SUBJECT: CALLAWAY PLANT - AMENDMENT NO. 124 TO FACILITY OPERATING
LICENSE NO. NPF-30 (TAC NO. M99918)

The amendment modifies the plant heatup and cooldown curves and the maximum allowable power operated relief valve setpoint for cold overpressure protection. We approved your request for an exemption from the requirements of 10 CFR 50.60 "Acceptance Criteria for Fracture Prevention for Light Water Nuclear Power Reactors for Normal Operation" in order to apply the American Society of Mechanical Engineers (ASME) Code Case N-514, "Low Temperature Overpressure Protection." The Code case was used in developing the cold overpressure mitigation system setpoints.

SAFETY EVALUATION BY THE OFFICE OF NUCLEAR REACTOR REGULATION

RELATED TO AMENDMENT NO. 124 TO FACILITY OPERATING LICENSE NO. NPF-30

FIGURE 3.4-2

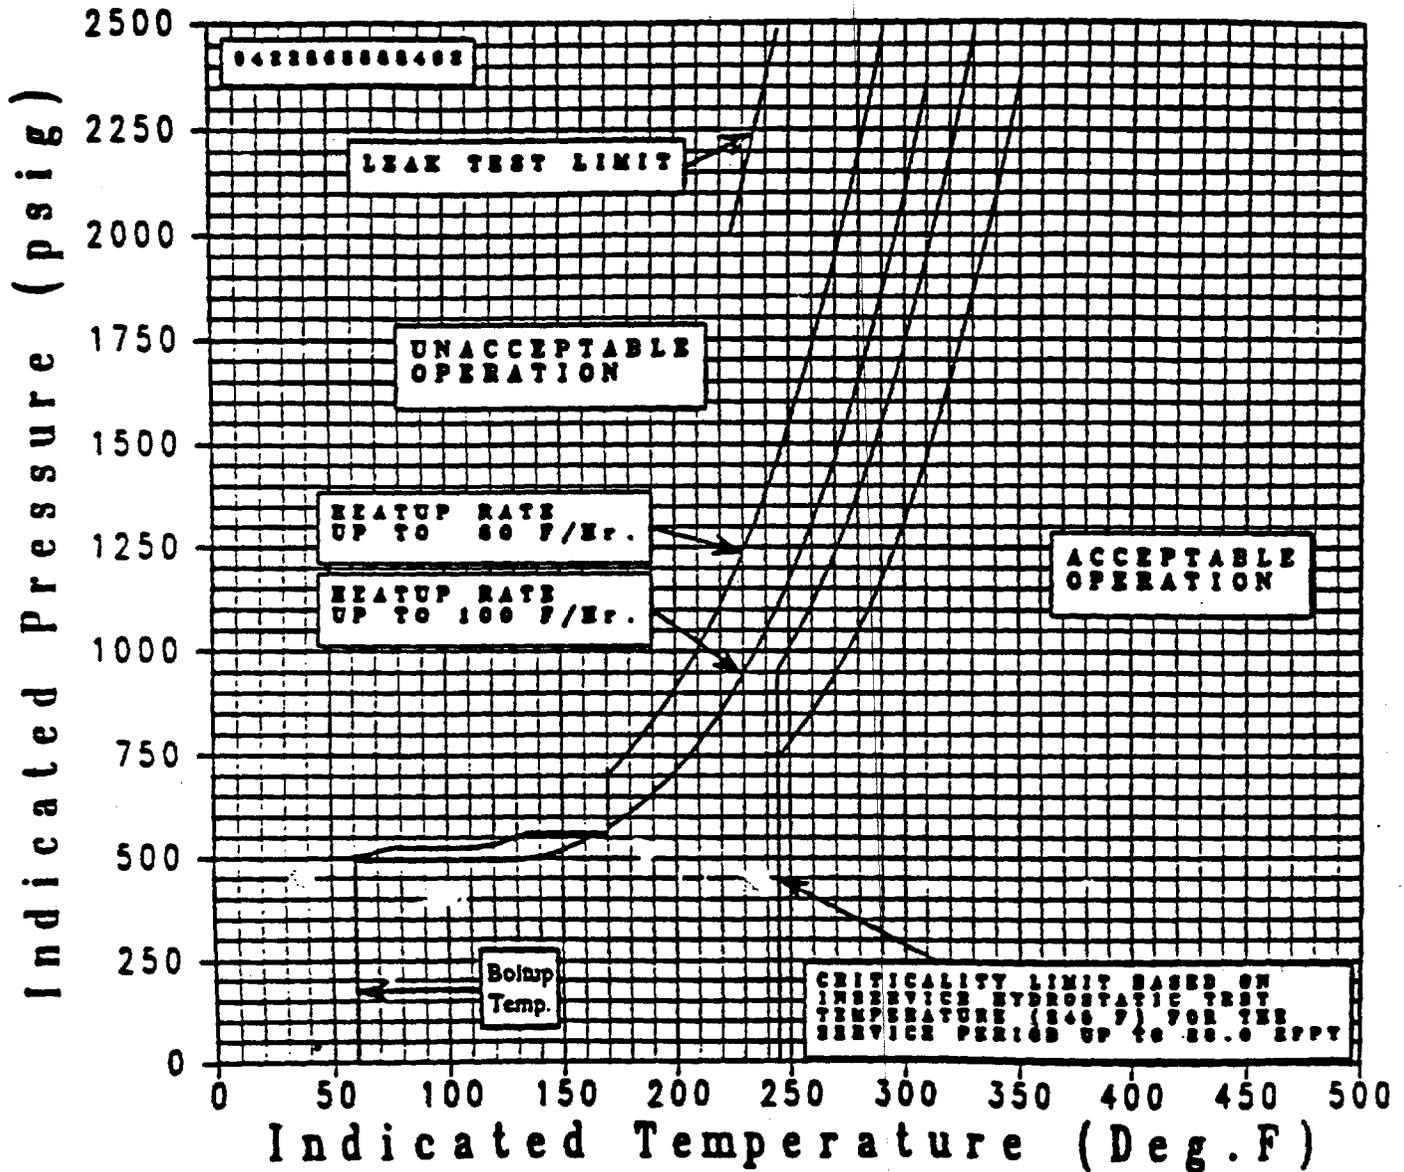
UE also requested to modify the plant heatup and cooldown curves and the maximum allowable power operated relief valve (PORV) setpoint curve for cold overpressure protection, as found in TS Figures 3.4-2, 3.4-3, and 3.4-4, respectively. These modifications are necessary for the plant to operate up to 20 effective full power years (EFPY), an increase from 17 EFPYs. In addition, TS Bases 3/4.4.9 and 3/4.5.2 through 3/4.5.4, which stated one of the two centrifugal pumps is allowed by the TS to be operational in MODES 5 and 6 operation with the reactor vessel head installed, are revised by including the "normal" charging pump to the centrifugal charging pump allowed to be operational. The modifications to these TS Bases are acceptable because they provide a consistency with Limiting Condition for Operation (LCO) 3.5.4, which requires all safety injection pumps and one of the two centrifugal charging pumps, but not the "normal" charging pump, to be inoperable while in MODE 5 and MODE 6 operation with the reactor vessel head on.

The cold overpressure mitigation system (COMS) uses PORVs located near the top of the pressurizer to supplement the water relief valves in the residual heat removal system (RHRS) suction lines for protection of the reactor vessel from being exposed to conditions of fast propagating brittle fracture. TS LCO 3.4.9.3 requires that, when the RCS temperature is below 368°F and the RCS is not depressurized with a vent of greater than or equal to 2 square inches, either two RHR suction relief valves, or two PORVs with setpoints not exceeding the limit established in Figure 3.4-4, or one RHR relief valve and one PORV shall be operable. The TS amendment request will revise the PORV setpoints in Figure 3.4-4 to prevent the RCS pressure from exceeding the pressure-temperature limits in the revised Figures 3.4-2 and 3.4-3 for operation up to 20 EFPYs.

Callaway Unit 1 Reactor Coolant System Heatup Limitations (Heatup Rtes of 60 and 100°F/hr) Applicable for the First 20 EFPY (With Margins for Instrumentation Errors) Includes Vessel flange requirements of 170°F and 561 psig per 10 CFR 50, Appendix G.

The staff concludes that the proposed P-T limits for the reactor coolant system for heatup, cooldown, leak test, and criticality satisfy the requirements in Appendix G to Section XI of the ASME Code and Appendix G of 10 CFR Part 50 for 20 EFPY. The proposed P-T limits also satisfy GL 88-11 because the method in RG 1.99, Revision 2 was used to calculate the ART. Hence, the proposed P-T limits may be incorporated into the Callaway Unit 1 Technical Specifications.

FIGURE 3.4-4

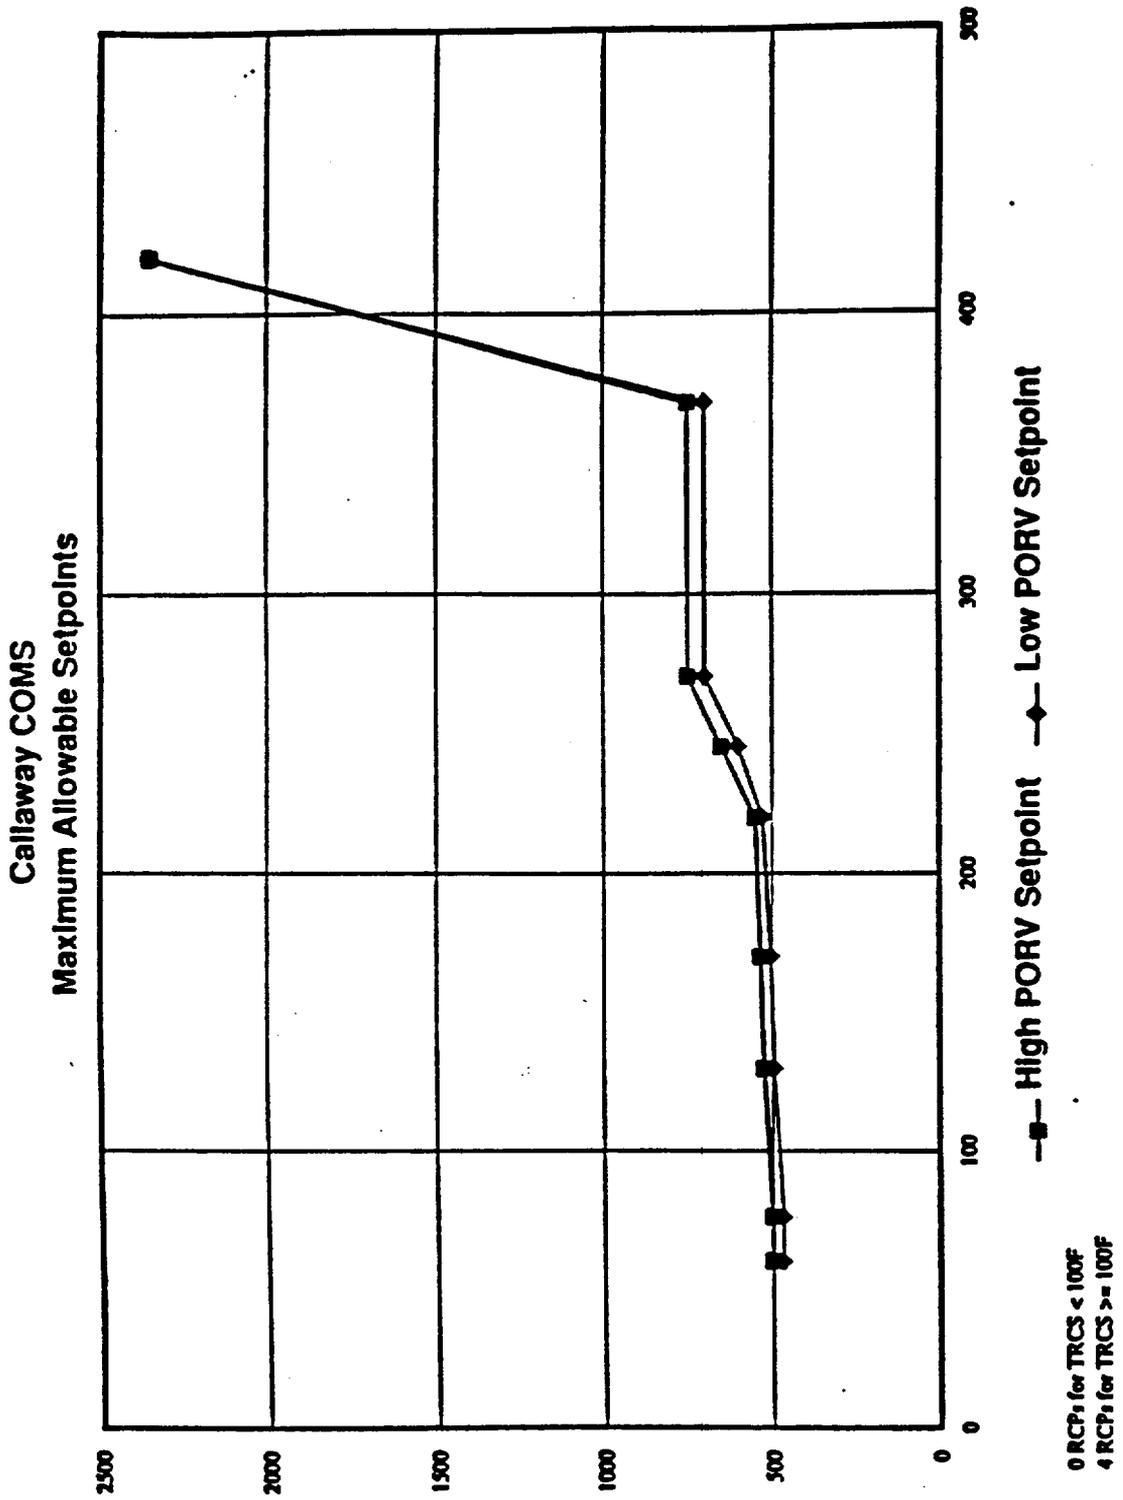
The COMS enable temperature and the PORV setpoints for 20 EFPYs are developed using the methodology described in the approved Westinghouse topical report, WCAP-14040-NP-A, Revision 2, "Methodology Used to Develop Cold Overpressure Mitigation System Setpoints and RCS Heatup and Cooldown Limit Curves," January 1996, as well as the guidelines of ASME Code Case N-514. Code Case N-514 requires the low-temperature overpressure protection (LTOP) systems to be enabled when the reactor coolant temperature is less than 200°F or at temperatures corresponding to a reactor vessel metal temperature less than RT_{NDT} (nil-ductility reference temperature) + 50°F, whichever is greater; and to limit the maximum pressure in the reactor vessel to 110% of the pressure determined to satisfy Appendix G. In WCAP-14894, "Callaway Unit 1 Heatup and Cooldown Limit Curves for Normal Operation," July 1997, the RT_{NDT} for 20 EFPYs is calculated to be 100.4°F. Based on the Code Case N-514 guidelines, the COMS enable temperature is 200°F. Therefore, TS LCO 3.4.9.1, which requires the COMS to be enabled at 368°F, is conservative.

The COMS PORV setpoints are determined based on the design basis analyses consisting of a mass input transient and a heat input transient, initiated with the RCS in a water-solid condition and the RHRS isolated from the RCS, disabling the relieving capability of the RHR relief valves. The heat injection scenario is the startup of a reactor coolant pump (RCP) with the steam generator secondary side hotter than the RCS temperature, resulting in a RCS pressurization from sudden heat input to a water-solid RCS from the steam generator. The mass injection scenario is caused by the simultaneous isolation of the RHRS, isolation of letdown and failure of the charging flow controls, resulting in an RCS pressurization from a net charging flow input to a water-solid RCS. The analyses of the heat and mass input transients were performed with the LOFTRAN computer code to determine the RCS pressure overshoot after a PORV is actuated. In addition, the uncertainties associated with pressure and temperature instrumentation, the single failure assumption of a PORV, as well as the hydrostatic and dynamic effects of the RCP are taken into account in the analyses.

The staff has reviewed the PORV setpoint analyses provided in the UE's March 3 and March 17, 1998, letters, including the RCS pressure overshoots for both the mass and heat input transients for the assumed RCS initial conditions and PORV setpoints, the treatment of pressure and temperature uncertainties, and the selection of the PORV setpoints with comparisons to the Appendix G limits and the limit established for maintaining the integrity of the PORV piping. The results show that, with the selected PORV setpoints at various RCS temperatures, the peak RCS pressures during both the mass and heat input transients are bounded by the Appendix G limits (multiplied by 110% per Code Case N-514 guideline) or the PORV piping pressure limit. Since the analyses were performed with the approved methodology of WCAP-14040, Revision 2, the staff concludes the PORV setpoint curves as specified in the revised Figure 3.4-4 are acceptable.
